**CABINET MEMBER FOR ENVIRONMENT – 26 MARCH 2020**  
**OXFORD: KIRBY PLACE AND DON BOSCO CLOSE– PROPOSED**  
**WAITING RESTRICTIONS**

**Report by Interim Director of Community Operations**

1. The Cabinet Member for the Environment is RECOMMENDED to approve proposed no waiting at any time restrictions at Kirby Place and Don Bosco Close, Oxford as advertised.

Drawing Number: **0005/A3/00153**

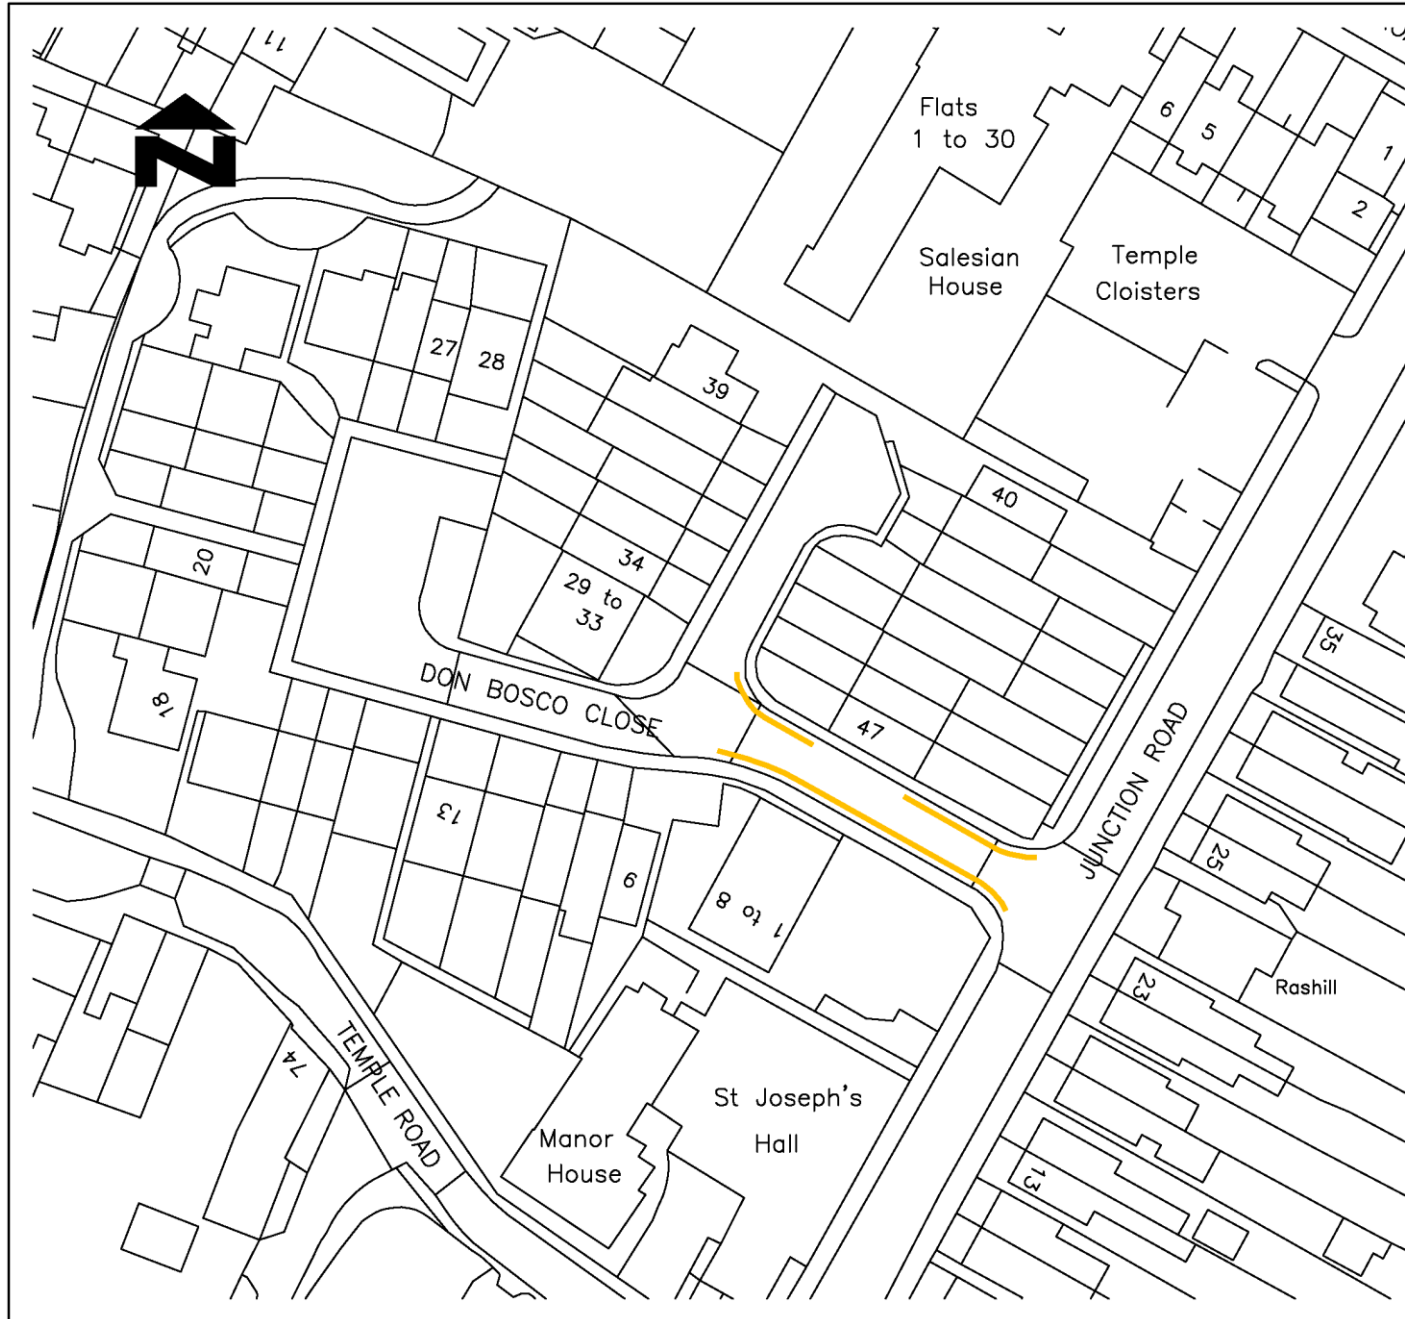
- Of the six objections all generally objected to the loss of parking opportunities. One supported the proposed prohibitions but only if permit controls were implemented first. This objector and another, who supported the proposals, felt that the proposed controls on the northwest side went too far and wanted the gap between the controls near number 47 increased. Concerns were also expressed about the pressure that the displaced vehicles would have on the surrounding area and a Landlord was concerned about where vehicles servicing his property would park.

(3) Local Resident, (Oxford)	<p>Don Bosco Close - <b>Object</b> Kirby Place - <b>No opinion</b></p> <p>If new restrictions are introduced piecemeal like this without a proper plan for residents' parking this will only exacerbate our current problems. Residents of Junction Road often rely on parking in Don Bosco Close, especially on weekdays, because all the space on our road is occupied by commuters, users of the doctor's surgery and library in Temple Road (for which no parking provision has been made although these are public services in regular use), and parents collecting children from local schools.</p> <p>What has happened to the formal consultation we were promised after the informal one came round last year? It is not acceptable that I had to find out about this proposal from a scrappy piece of paper on a lamppost near the library. There has to my knowledge been no information delivered to residents who will be directly affected and it has taken me 15 minutes of online searching to find this consultation.</p>

<p>(4) Local Resident, (Oxford)</p>	<p>Don Bosco Close - <b>Object</b> Kirby Place - <b>No opinion</b></p> <p>I see no reason for the restrictions on Don Bosco close. There is no through traffic or danger as far as I can see.</p>
<p>(5) Local Resident, (Oxford)</p>	<p>Don Bosco Close - <b>Object</b> Kirby Place - <b>No opinion</b></p> <p>There are always 4-6 cars parked in this area, regardless of whether it is day, night, week or weekend. Restricting the parking here would push these cars to park on Junction Road. As a resident of Junction Road, I find it is getting harder to find a parking spot by our house and would be concerned that if this were implemented, it would get harder still. I would be interested in considering residents parking on Junction Road if the restrictions on Don Bosco go ahead.</p>
<p>(6) Local Resident, (Oxford)</p>	<p>Don Bosco Close - <b>Object</b> Kirby Place - <b>No opinion</b></p> <p>I have been made aware of the proposal to introduce a 'No Waiting at Any Time' parking restrictions on Don Bosco Close by my current tenants. I have a four bedroom HMO property at no:42 that requires regular maintenance involving a variety of contractors that carry out works at the property throughout the year. In order for them to conduct these works they often rely on street parking. This proposal would drastically affect the ability for these contractors to park their vehicles in order to service the property.</p> <p>I have owned the property at 42 Don Bosco Close for 14 years now and have never known of any difficulty for emergency services to access the close during which time weekly refuse lorries have consistently had no problems with accessing all properties.</p> <p>If this proposal is to go ahead I would urge you to put a suitable allowance in place that allow for properties to be serviced by works vehicles.</p>

(8) Local Resident, (Oxford)	<p>Don Bosco Close - <b>Object</b> Kirby Place - <b>Object</b></p> <p>I live in Junction Road and recently I have had to park in Don Bosco Close the majority of the time. On-road parking in Temple Cowley has become more difficult in the past couple of months, coinciding with the completion of the development of the Temple Cowley Pool site. The City Council was well aware that Temple Cowley could not absorb any more traffic, yet granted planning permission for the development of 48 units, with only 29 allocated parking spaces. Sher Afzal Close is wide enough for cars to park on one side at least, and could be wider still if the pavement were not so wide. Infill new developments with lovely open spaces should not be built at the expense of existing households.</p> <p>As a result of the new development, there is now a need for more on-road parking, not less. If you restrict parking in Don Bosco Close and Kirby Place, the cars that currently park there will have nowhere to go. If you keep these roads open for parking, the situation is no different to most of the side streets in East Oxford, where cars, emergency services and waste-collection lorries have to negotiate narrower road widths than in Temple Cowley.</p> <p>However, Don Bosco Close is very wide: there is no need to restrict parking on both sides of the road. Kirby Place is</p>

<p>(9) Local Resident, (Oxford)</p>	<p>Don Bosco Close - <b>Neither</b> Kirby Place - <b>No opinion</b></p> <p>I strongly support the double yellow lines on the SW side of Don Bosco Close, and on the curved parts of the NE side.</p> <p>However, I think that the lines on the NE side (by no 47) are too long for their intended purpose. My concern is that this will likely serve to displace parked cars into less suitable areas of the close. After all, the same number of cars will want to park in the neighbourhood as before - the proposed changes will not affect demand for parking.</p> <p>The only way to stop this would be to enact broader measures to encompass the entire street, which is not what is being proposed.</p> <p>My proposal would be to shorten the length of the proposed double yellow lines on the NE side, to just the two curved sections of the kerb, plus an extra few meters (say ~5m) near the junction with Junction Road to aid cars passing each other. This would still leave about 20-25m for cars to park on the NE side of the road, rather than the 9m of parking which is being proposed.</p> <p>As far as I can see, this will still achieve the requirements in terms of better access, and better visibility for vehicles and pedestrians, while still allowing for some parking in a relatively safe location.</p>

<p>(10) Local Resident, (Oxford)</p>	<p>Don Bosco Close - <b>Neither</b> Kirby Place - <b>No opinion</b></p> <p>As a resident of Don Bosco Close I welcome some of the proposed Parking restrictions, however I am concerned that individuals will attempt to park in the wider roadway at the bottom of Don Bosco Close, already sometimes people park next to each other limiting movement here, and for the purpose of making access better these proposals may just displace the issue. I believe that expanding the central portion of the north side of the road to allow a little more space would still allow for vehicles to manoeuvre in and out of the close. Perhaps a couple of metres on either side of the current proposed clear space.</p>
<p>(11) Local Resident, (Oxford)</p>	<p>Don Bosco Close - <b>Support</b> Kirby Place - <b>No opinion</b></p> <p>WE fully support the County Councils proposed restrictions for no waiting on the narrow entrance road to Don Bosco Close. Unregulated parking on the entrance road off Junction Road causes major problems for residents and refuse lorries entering the Close.</p>

- While it is accepted that approximately four or five cars would be displaced the amount of controls proposed are those needed to protect the minimum ten metres around junctions recommended in the Highway Code and a dropped kerb. Others are to prevent vehicles simply swapping sides of the road where none currently park.

Drawing Number: **0024/A3/00151**

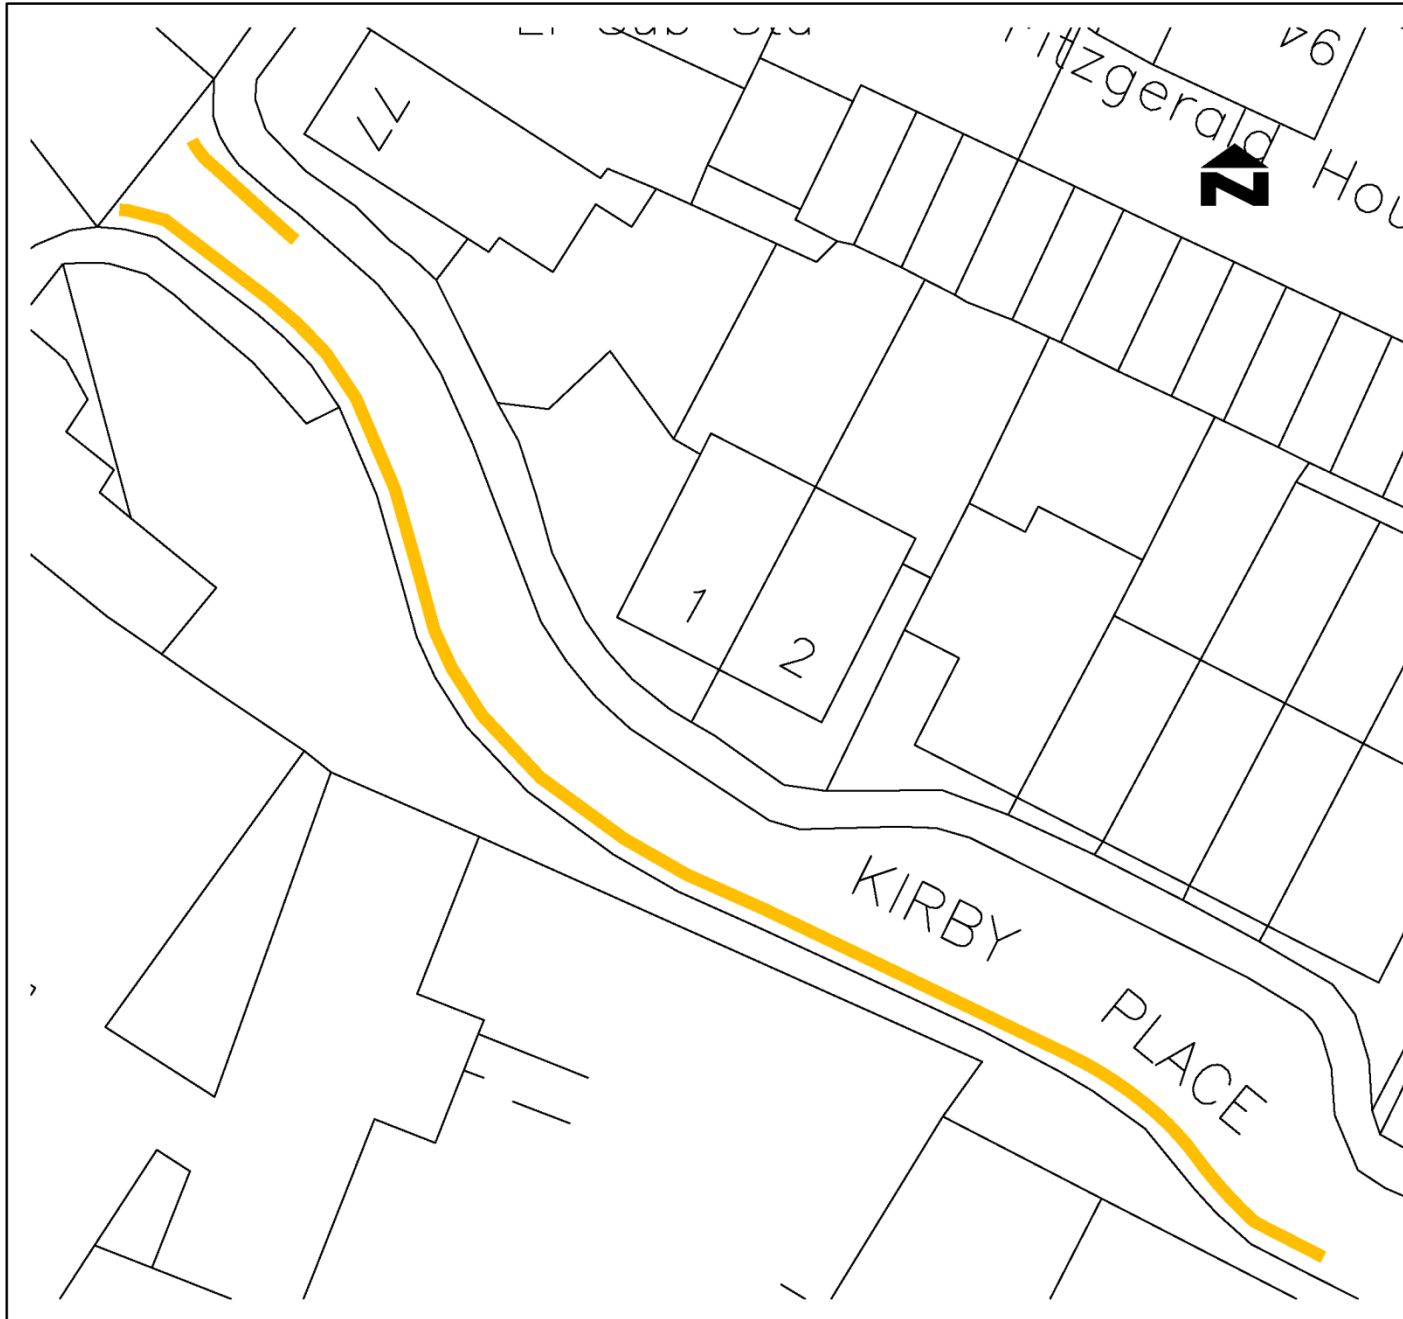
<p>I object in the strongest terms to these proposed parking restrictions. If the proposed restrictions in Kirby Place and Sher Afzal Close are approved, then the current parking problem will be pushed further up the road. Temple Road and Junction Road will become even more difficult for residents to park in than it currently is and if the double yellow lines are extended as proposed into Don Bosco Close it will be almost impossible for residents to park near their homes. Parking for residents in this area and the surrounding area is increasingly under pressure due to an increase in use of the parking bay in Junction Road from local commuters, Oxford Brookes students who have cars, parents parking during school hours, local schools and businesses, contractors working on housing projects (which looks to continue). Residents in Junction Road find it very difficult to park in the bays outside their houses for the above reasons.</p> <p>If there were double yellow lines in Don Bosco Close as outlined in the proposal, this would remove parking space for residents in Junction Road when they are unable to park in the parking bays on Junction Road because the spaces are being taken up by non-residents.</p> <p>We need a CPZ in the parking bays in Junction Road before these proposals could even be considered as potential options. What is the purpose of these restrictions other than depriving local residents of much-needed parking spaces?</p>

<p>both narrow and quite bendy, but why not restrict parking on one side only?</p> <p>Any new restrictions should be limited to those that are absolutely necessary (i.e. on bends, or one side only) and should not be implemented until a controlled parking zone has been introduced for Temple Cowley residents who do not have off-road parking, to protect existing households and ensure that students at Oxford Brookes University do not bring cars to Oxford.</p> <p>I would love to be able to cycle to work, and did so for many years, but currently have to travel Milton Keynes, a five-hour round trip by public transport, door-to-door. No car, no job, and the same is true for many Council taxpayers. We live on a small, crowded island with house prices and stamp duty land tax at levels that necessitate high-impact lifestyles for those unable to find work in Oxford, and there's no point in pretending otherwise.</p>

(20) Local Resident, (Oxford)	<p>Don Bosco Close - <b>No opinion</b> Kirby Place - <b>Support</b></p> <p>I would urge, as a resident further into Kirby Place, where the majority of non-resident parking actually takes place, that the council consider adding double yellow lines in part to the south of the hedge adjacent number 14, so that only one vehicle may park - this avoids the drive up, into and out parking for numbers 15, 16, 17 and parking spaces of numbers 4, 5 and 6 being hindered and also avoids a turning restriction for any emergency vehicles, especially a fire tender, should they need to gain access. Similarly I would urge the council consider placing double yellow lines to the west of number 20, along the adjacent brick boundary wall with Bennett Crescent, to a length of 3 metres, to give a gap between potential visitor or non-resident parking at number 20 parking access and other reversing vehicles.</p> <p>Furthermore, whilst I wholeheartedly thank the council for their proposals, can they assure residents that they are</p>

<p>(23) Local Resident, (Oxford)</p>	<p>Don Bosco Close – <b>No opinion</b> Kirby Place - <b>Object</b></p> <p>Kirby Place is not a through road. The restrictions would make it difficult for residents to park. Furthermore, guests visiting would have nowhere to park nearby; after residents have scrapped-over/taken the space left in the unrestricted zone. The current parking situation has not caused me any difficulty to park at in my designated bay at the end of Kirby Place (which entails driving past the proposed restricted zone).</p> <p>Therefore, it is my belief the proposed restrictions do not deliver any benefits to the residents. Only a hindrance.</p>

<p>(25) Local Resident, (Oxford)</p>	<p>Don Bosco Close – <b>No opinion</b> Kirby Place - <b>Support</b></p> <p>We are all in favour of the double yellow lines proposed for our road. We have been inundated with parking for the last two years by builders, police, people using the doctors and the library and even people parking all day and going to work elsewhere, to the extent that we cannot park anywhere near our own houses. There have even been occasions when people have parked both sides of our road which is very narrow and twice the refuse collection vehicles were unable to get through to empty the bins at the top of the road. Imagine if emergency vehicles could not get through!</p>

- The extent of the proposals in Kirby Place were developed following a site meeting with a member of Oxford City Council, local residents and representatives of Oxford Direct Services who indicated where cars parked at that time were hampering waste collection service.
- The request for additional lines in Kirby Place is noted but this is probably best dealt with as part of a possible permit parking scheme since concerns have been received about the loss of parking opportunities due to the displacement it will cause for residents in the road and nearby development.
